## SUMMARY OF: PMA # P050023/S076 AND P980023/S057

### ILESTO/IFORIA DF4 ICD-CRT-Ds AND PROTEGO DF4 LEADS

#### Executive Summary

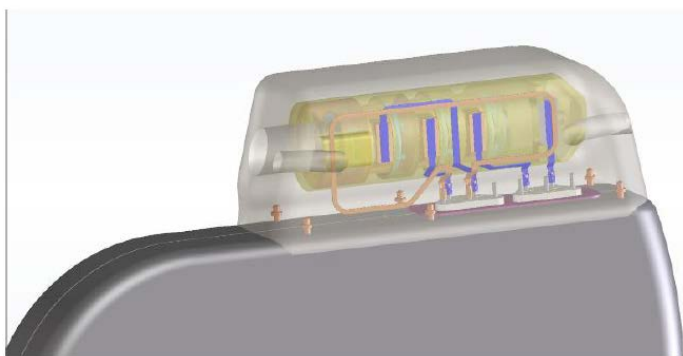
*LEAD REVIEWER COMMENTS: Overall, I agree that the DF4 connector port will have limited clinical impact. As for the DF4 connector on the lead, I believe the removal of the trifurcation/bifurcation in the predecessor leads removes transition areas and potential points of failure. However, as the firm states above the over device functionality remains unchanged and from that standpoint I agree with the limited clinical impact.*
